SERVICE No. 140 BULLETIN

SUBJECT: PA-23 Landing Gear CO₂ Extension System

MODELS AFFECTED: PA-23, Serials 23-1 to 23-246 inclusive

SHUTTLE VALVE-LOCATED,
RIGHT SIDE OF FUSELAGE
FRAME, AT STATION #36 1/4

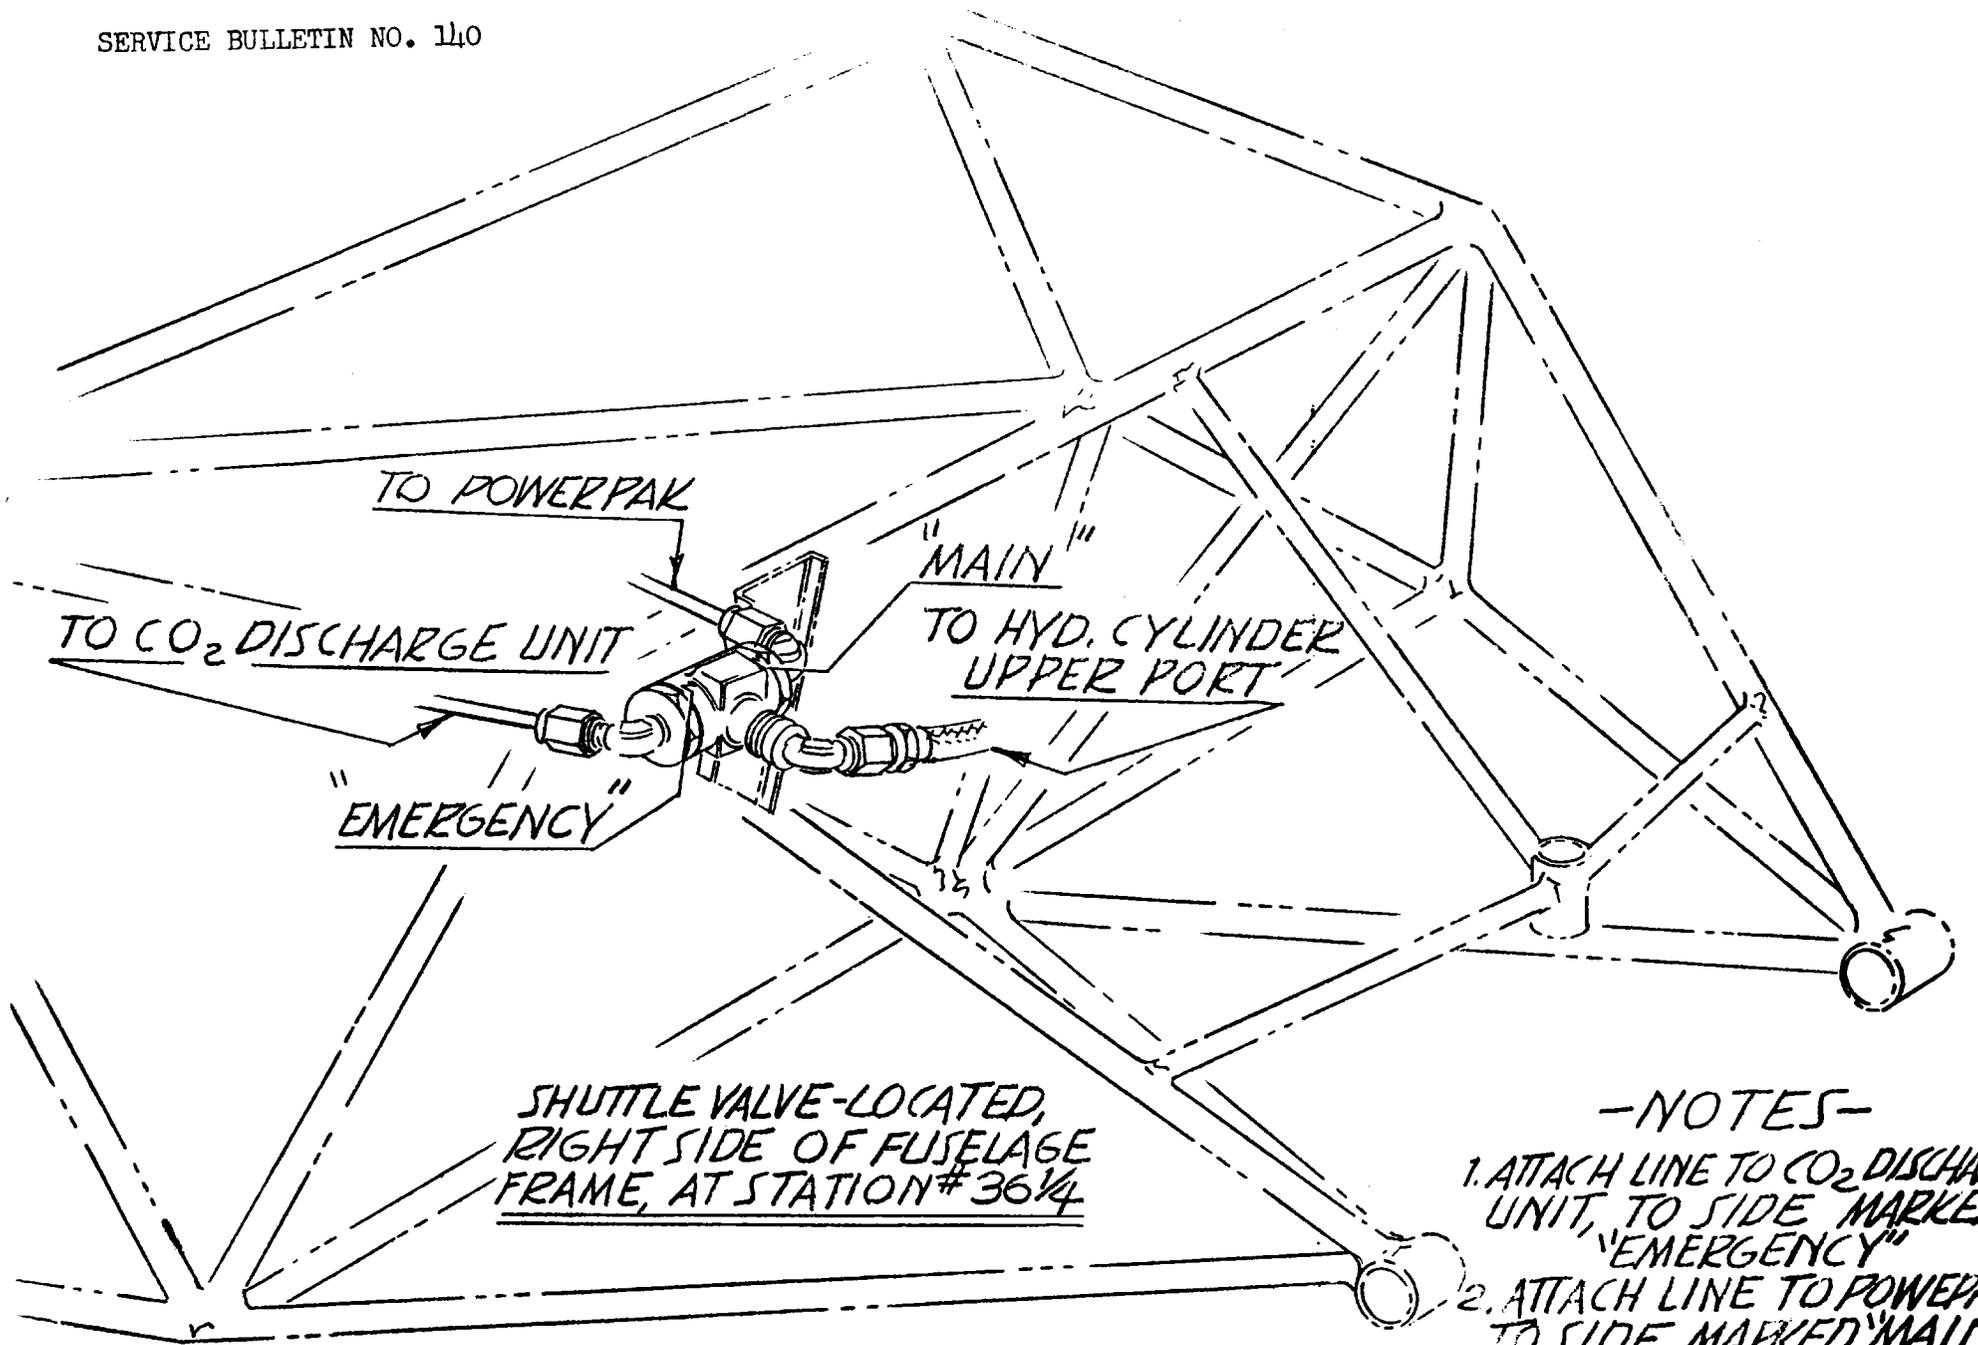
From operational experience in the subject airplanes it has been found that the nose wheel shuttle valve can become unseated, thereby permitting the CO₂ system lines to be filled with hydraulic fluid locking the landing gear in the down position.

The only means of retracting the gear is to bleed the CO₂ system lines. Therefore, in order to eliminate this condition it is necessary to immediately install one spring loaded shuttle valve at the nose wheel actuating cylinder in accordance with the sketch shown on the reverse side of this bulletin.

NOTE: Care should be taken in installing the new nose wheel shuttle valve to see that the airplane is put on jacks and that the main hydraulic line is attached to the end of the shuttle valve marked MAIN, and the CO₂ line is attached to the end of the shuttle valve marked EMERGENCY.

1. ATTACH LINE TO CO₂ DISCHARGE UNIT, TO SIDE MARKED "EMERGENCY"
2. ATTACH LINE TO POWERPAK TO SIDE MARKED "MAIN"
